re: **Geotechnical Design Parameters - Infiltration Gallery  
Proposed Residential Development  
Wateridge - Block 29 - Wanaki Road - Ottawa**

date: November 1, 2019

file: PG4965-MEMO.03

- ☐ General Plan of Services, Project No. 119066-00, Drawing No. 119066-GR, Revision 3 dated September 18, 2019.

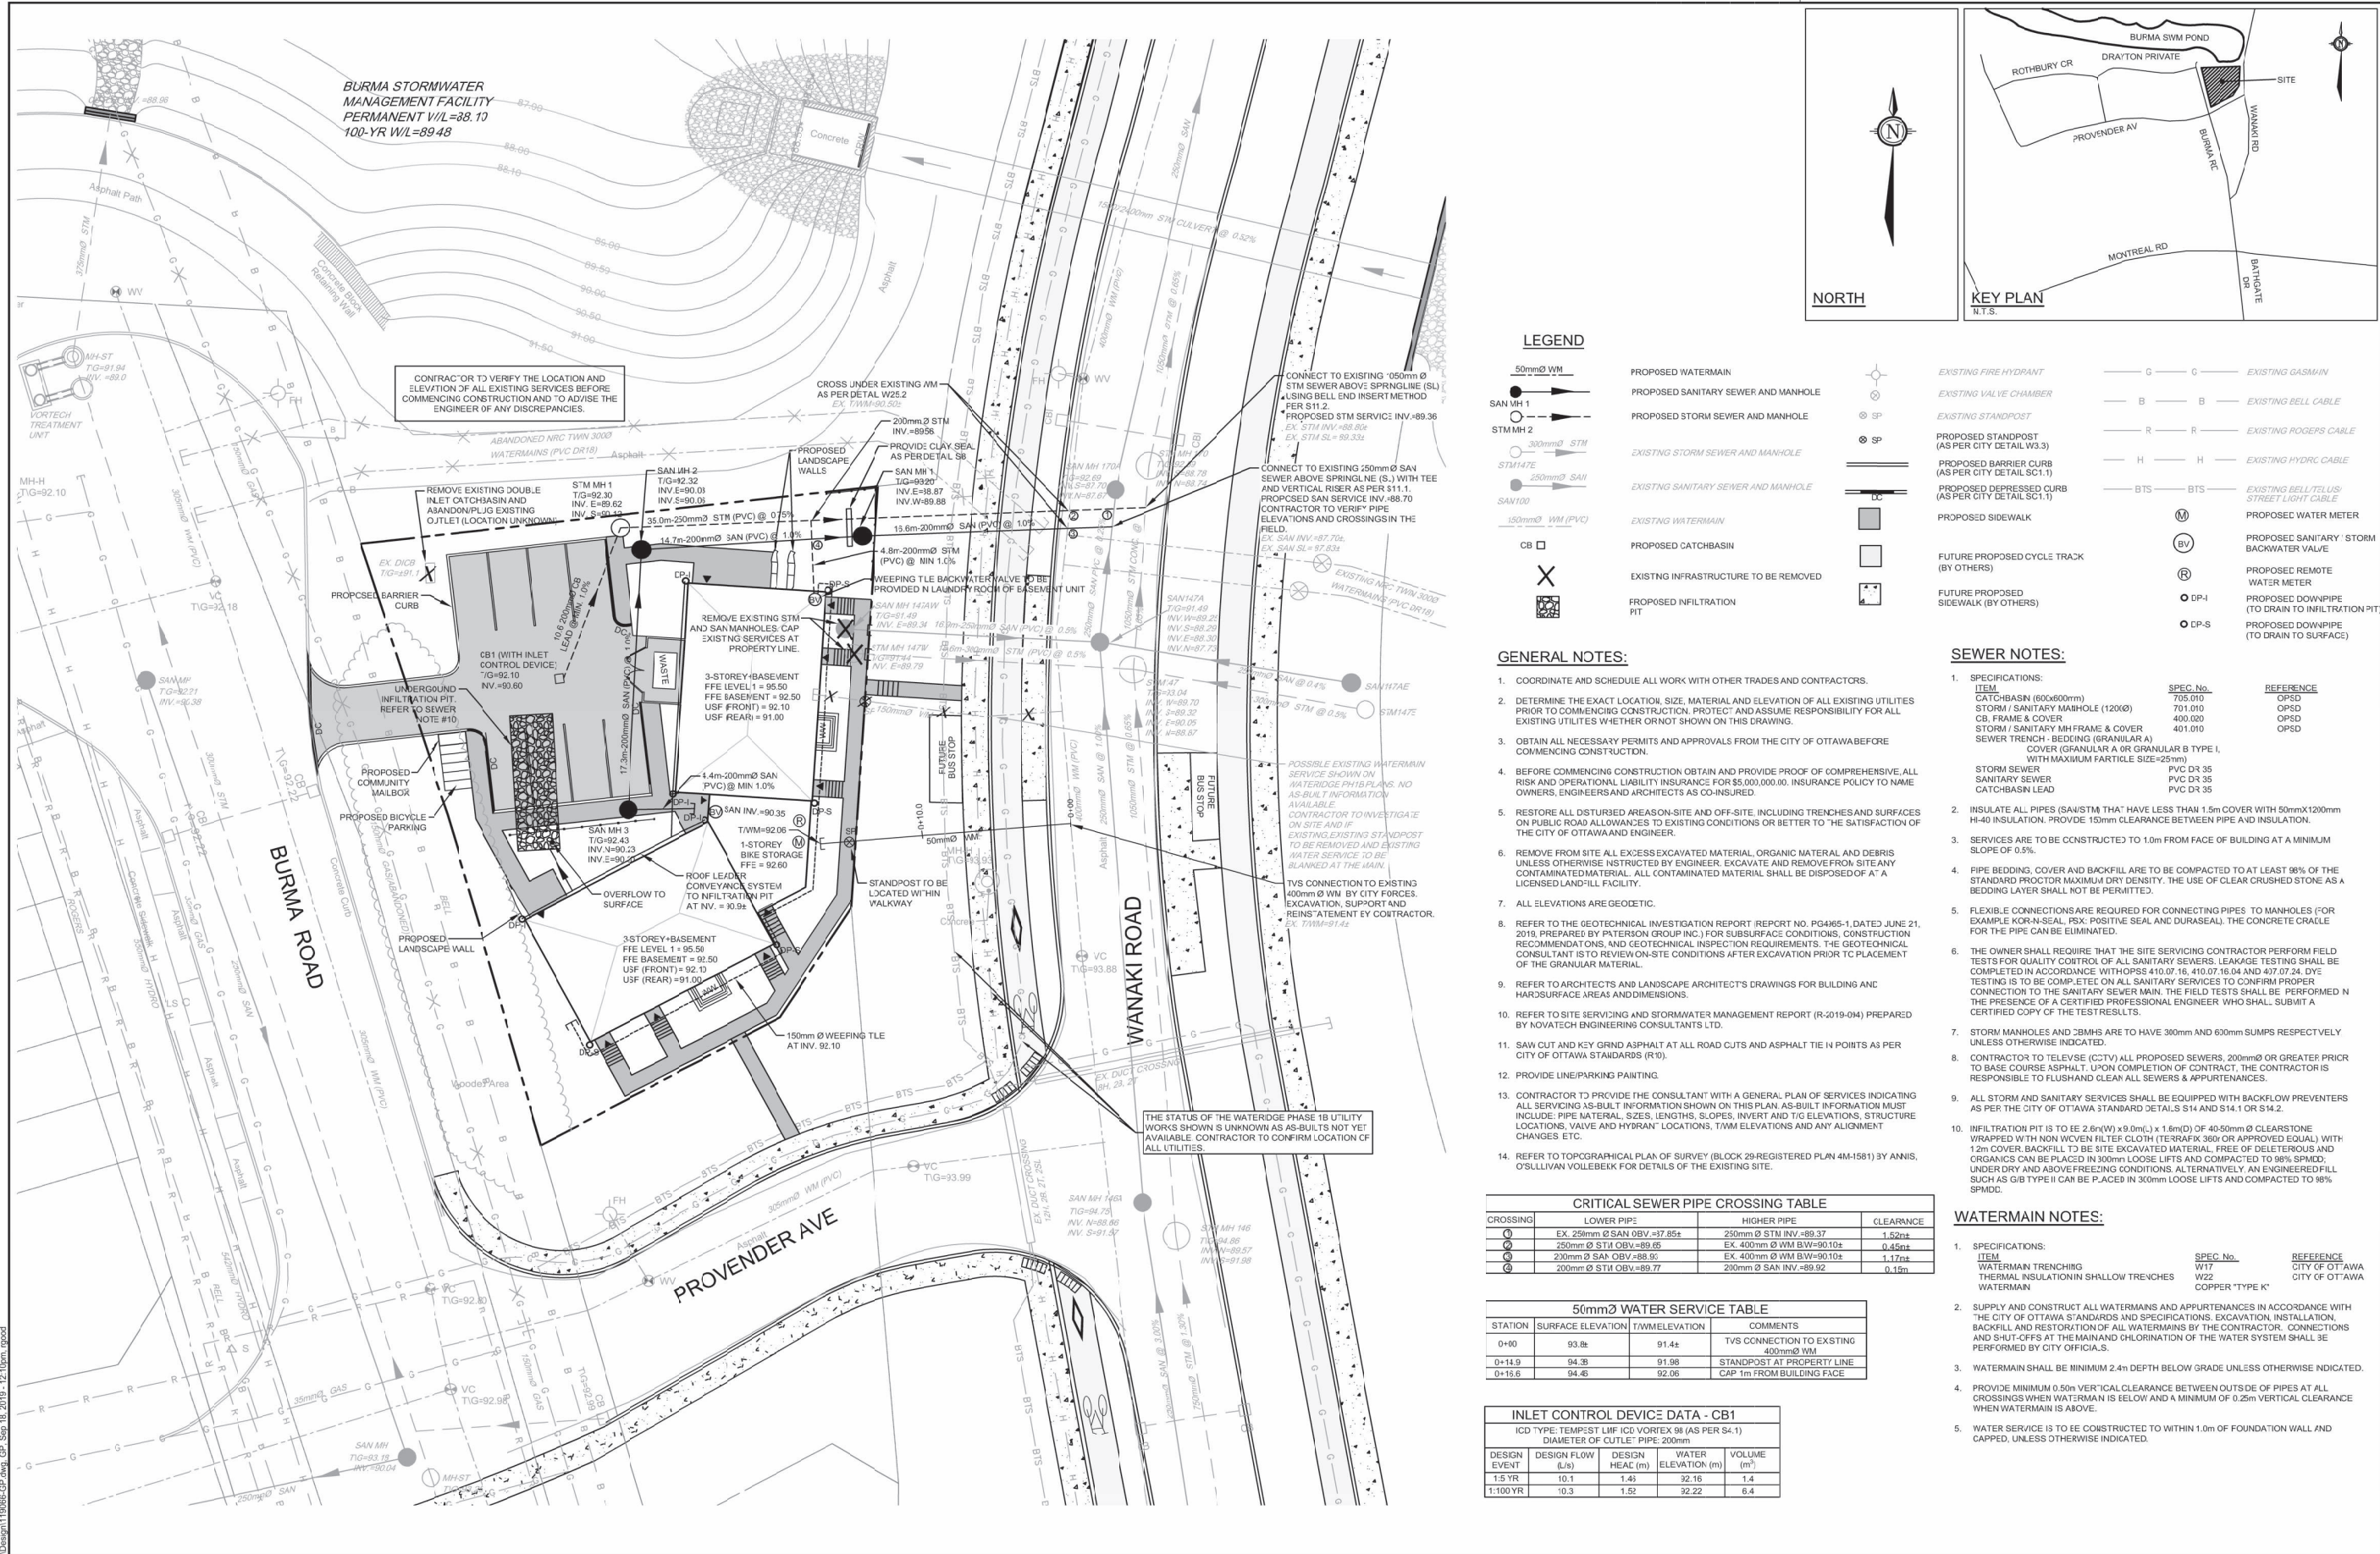
Based on the above noted drawings, it is expected that the subsoil conditions expected at the base and sidewalls over the infiltration gallery will consist of a very stiff to stiff brown silty clay. It should be further noted that the long-term groundwater level is located below the bottom of the infiltration gallery based on the dimensions provided in Note #10 presented on the aforementioned drawing. It is anticipated that the long-term groundwater will not effect the performance of the infiltration gallery and sufficient separation between the invert level and the long-term groundwater level is present.

The following hydraulic conductivity values can be used for the design of the system based upon previous experience at similar sites in the immediate area with similar stratigraphy and typical published values for very stiff to stiff brown silty clay. The hydraulic conductivity value was conservatively estimated to be in the order of  $1 \times 10^{-6}$  to  $1 \times 10^{-8}$  m/sec. Based on the above noted hydraulic conductivity values, the approximate infiltration rates will range from 14 to 46 mm/hr. It should be noted that a safety correction factor was not applied to the above noted infiltration rates for calculating the design infiltration rates.
